From: Jan Zimmerman
To: Risher, Bruce
CC: jbrandt@dfg.ca.gov; shannon.l.pankratz@usace.army.mil
Date: 2/6/2012 8:51 AM
Subject: Re: Meadowbrook Woods- Serenity Retreat and Conference Center

From: "Pankratz, Shannon L SPL" <Shannon.L.Pankratz@usace.army.mil>
To: JZimmerman@waterboards.ca.gov
Date: 2/9/2012 4:32 PM
Subject: RE: Meadowbrook Road, Crest Park - Inspection 02/06/2012 (UNCLASSIFIED)

Jan Zimmerman - Restoration Plan - Arimol Group, Inc. - 1031 Meadowbrook Road, Crest Park, CA

Streambed Restoration Plan for Effected Waters of the US on the 1031 Meadowbrook Road Project

Figure 2
Location of Historic Streambed

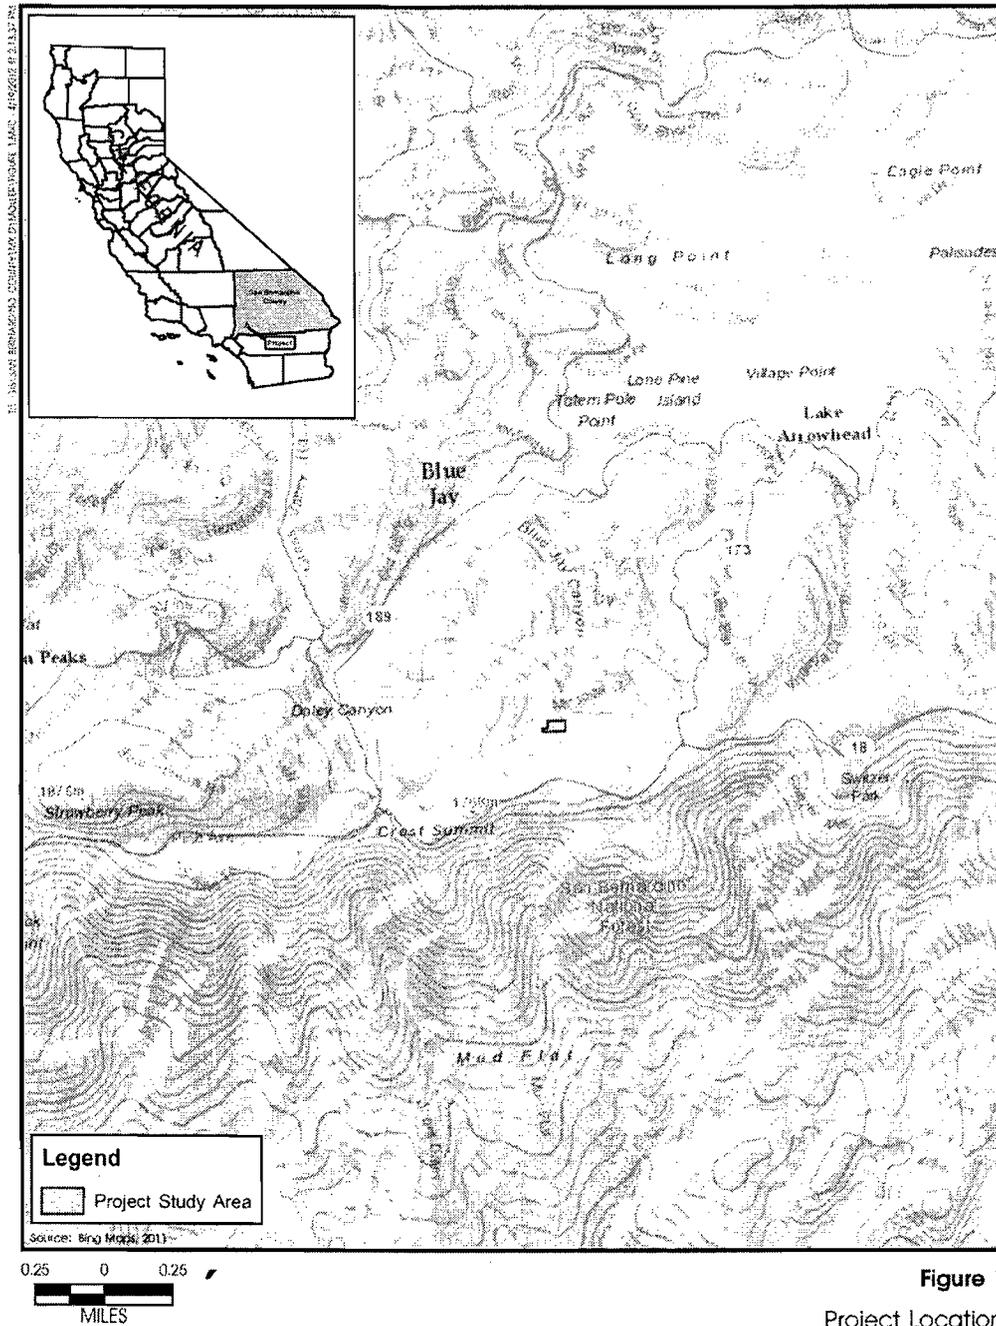
- 2. The Department does not concur with the historic streambed alignment depicted in Figure 2. Please conduct a thorough analysis of all available historic and recent aerial photography to map the pre-impact location of the streambed, associated riparian vegetation, and the associated meadow. Please also ensure that the springs to the west of APN: 0036-013-402 are mapped, and any other jurisdictional areas west of the project site, and west of Meadowbrook Road, are mapped.**

Please see the Kadtec Stream Bed Grading Plan, enclosed, for details regarding historical extent and location of jurisdictional waters on and adjacent to the property.

STREAM BED GRADING PLAN

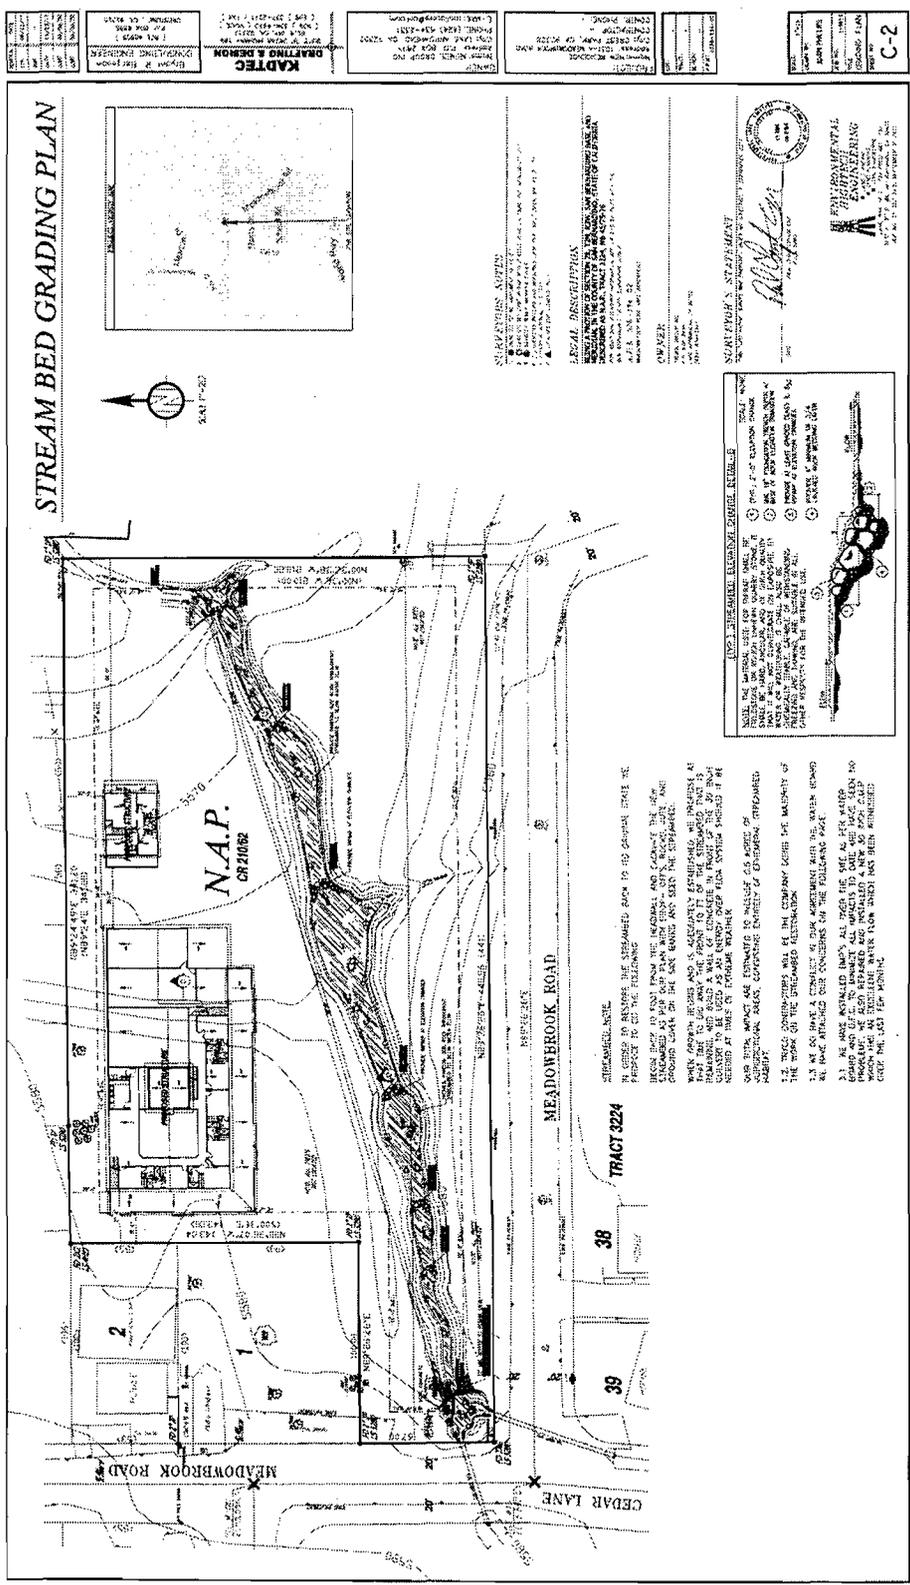
On August 29, 2012, Water Board staff received your revised plans regarding the Meadowbrook Road property and restoration of the main streambed across the property. Although the plans only roughly approximate the mapped “blue line” on Figure 2 of your July 2012 submittal, Water Board staff are authorizing you to proceed with removal of the headwalls and culvert pipe up to the N.G. 5574.19/F.G. 5572.63 line indicated on your “Streambed Grading Plan” received on August 29, 2012. As part of this activity, you must ensure that the remaining downstream pipe culvert is completely blocked off so that water can no longer enter this pipeline as it flows generally from west to east at the N.G. 5574.19 line. As stated in your submittal, you intend to obtain a grading permit from the County of San Bernardino before proceeding with this work.

Please see the Kadtec Stream Bed Grading Plan, enclosed, for details regarding historical extent and location of jurisdictional waters on and adjacent to the property.

Figure 2

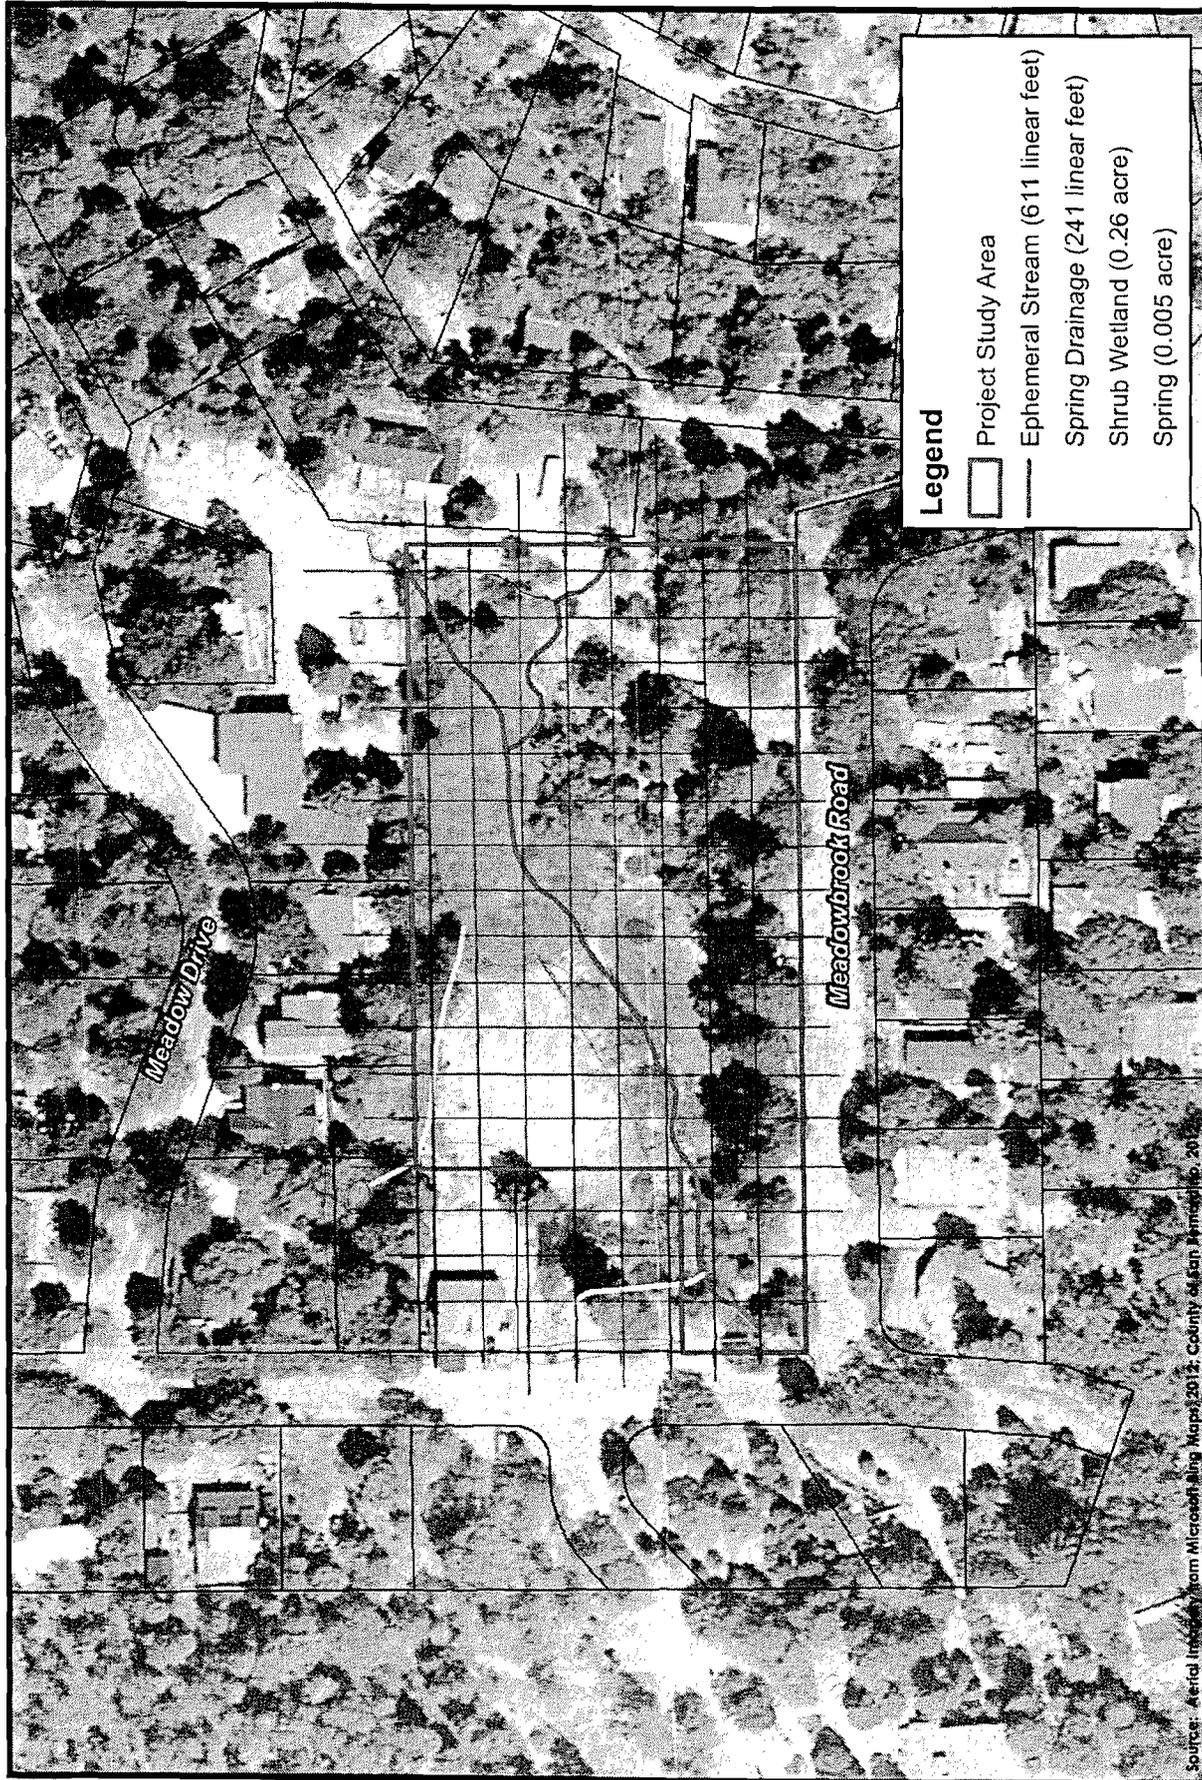
- Introductions
- Purpose of the meeting:
 - **Remove headwall and pipe culvert forthwith**
 - Restore to pre-development conditions along historic streambed
 - Restore along blue line presented on Figure 2 of submittal
 - Survey restored stream location. Must match Figure 2 blue line
 - Redefine wetland area to include all wetlands
 - Use appropriate BMPs

The locations of the springs and their associated drainages have been mapped, and are depicted on the enclosed **Figure 2**. Additionally, impacts to these features have been quantified and compensated for in the proposed restoration plan (**HMMP**).
